Subject: Permit Modification Request for the Waste Isolation Pilot Plant Hazardous Waste Facility Permit, Number NM4890139088-TSDF

- Clarification of TRU Mixed Waste Disposal Volume Reporting

Class 2 Permit Modification Request
Clarification of TRU Mixed Waste Disposal Volume Reporting
Waste Isolation Pilot Plant
Carlsbad, New Mexico
WIPP Permit Number - NM4890139088-TSDF

Appendix C
Supplemental Information

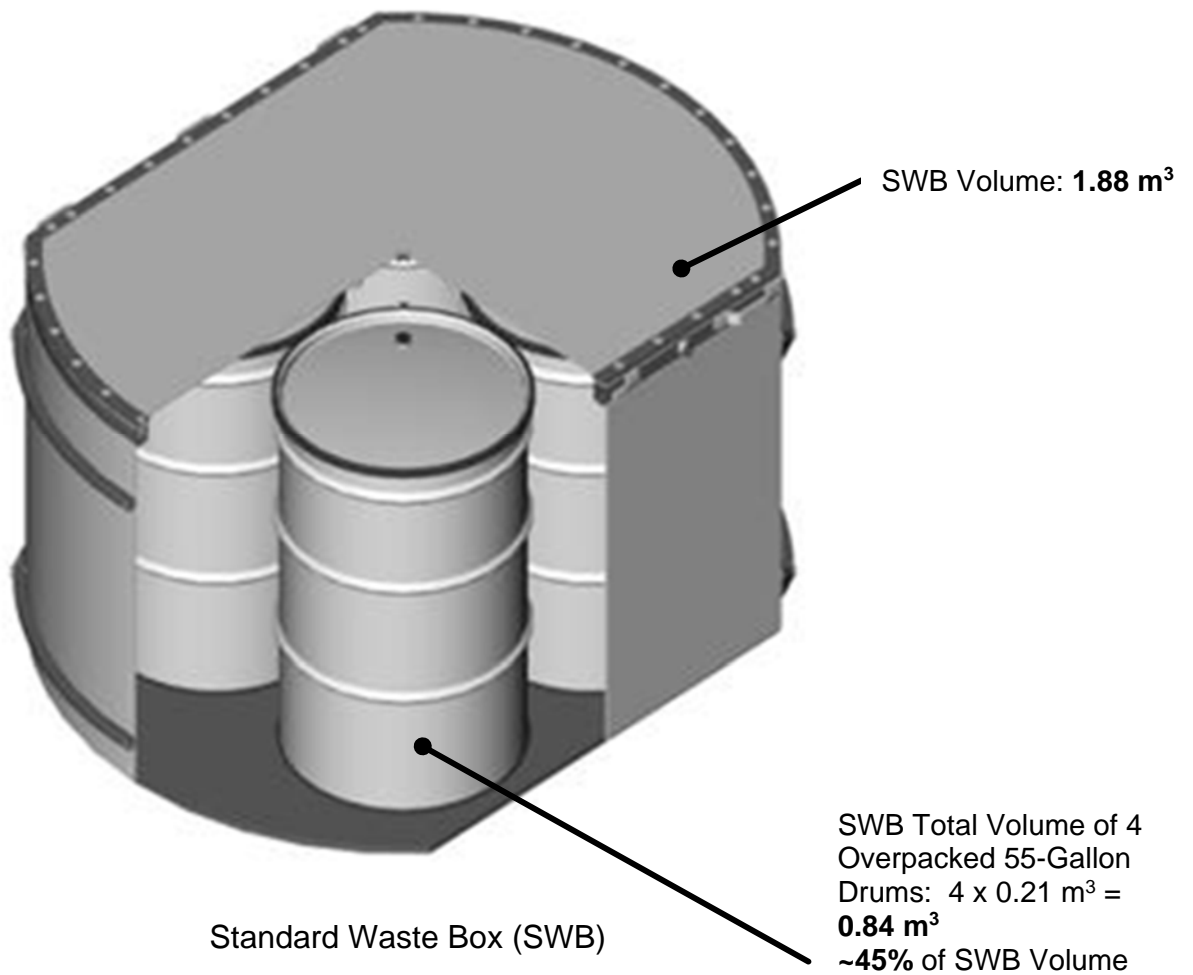
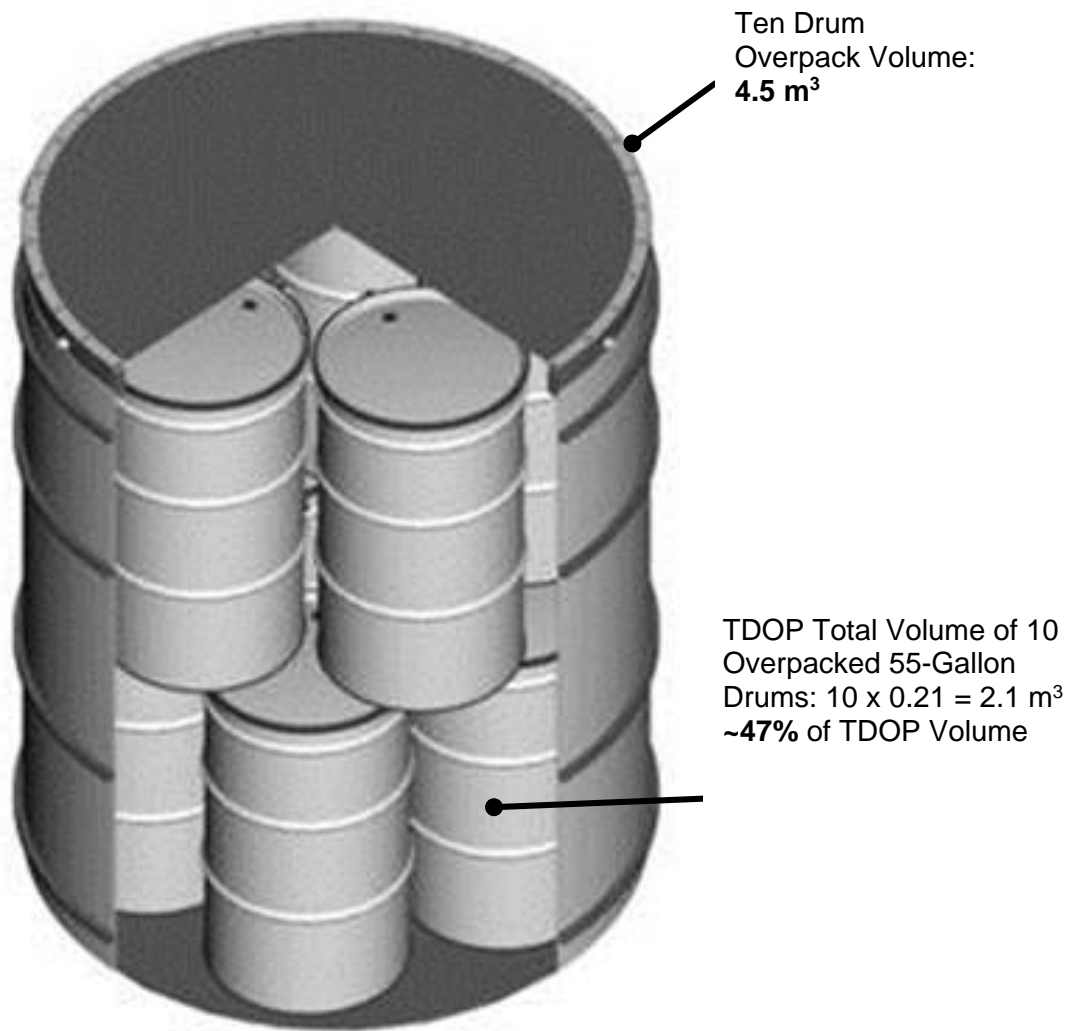
- Change the final RH TRU mixed waste volume reported for Panel 6 from 7,500 ft³ (214 m³) to 7,600 ft³ (215 m³). The final RH TRU mixed waste volume reported for Panel 6 in the current Permit includes the inner container volume of the nine shielded containers emplaced in Panel 6. The inner container volume of the shielded container is 30 gallons [(4.0 ft³) (0.11 m³)] and the outermost container volume is 55 gallons [(7.4 ft³) (0.21 m³)]. This change is needed to be consistent with the proposed definition, 1.5.21., *TRU Mixed Waste Volume*. Note that this change only applies to Panel 6 because shielded containers have only been emplaced in Panel 6. Note also that the volumes reported in Table 4.1.1 in ft³ are rounded to the nearest 100 ft³.

- Experience with packaging waste at the generator/storage site has resulted in waste containers that are not full as assumed in the ROD. Generator/storage sites limit the amount of waste in a disposal container based on radiological and physical (e.g., weight) parameters. In some cases, smaller containers are placed into larger containers (referred to as overpacking) in order to deal with container integrity issues or to achieve more efficient shipping configurations. As more and more waste is packaged and shipped, the difference between the waste volume used to determine the ROD/C&C/LWA limits and the volume of the waste container increased such that it has reached the point where comparing disposed TRU mixed waste volume pursuant to the Permit limits no longer accurately reflects the authorized volume pursuant to the ROD/C&C/LWA. For example, the volume of contact-handled TRU mixed waste disposed as of December 6, 2017, based on the outermost container volumes is 3,238,673 ft³ (91,709 m³) while the volume based on the innermost container volumes, which would more accurately reflect the LWA TRU waste volume of record, is 2,307,708 ft³ (65,347 m³). Note that this volume information was obtained from the WWIS. The WWIS is described in Permit Attachment C, Section C-5a(1), *WWIS Description*. The WWIS database is the single database used by the Permittees to record the types and quantities of TRU mixed waste characterized, managed, stored and disposed at the WIPP facility. There is sufficient container data information in the WDS to query and report waste volumes as needed pursuant to the proposed definitions. Examples of some commonly used overpacks are provided in Appendix C of this PMR. The volumes of the outermost overpack containers versus the volumes of the innermost containers being overpacked are included in these examples to illustrate the significant differences in the outermost container volumes versus the innermost container volumes.
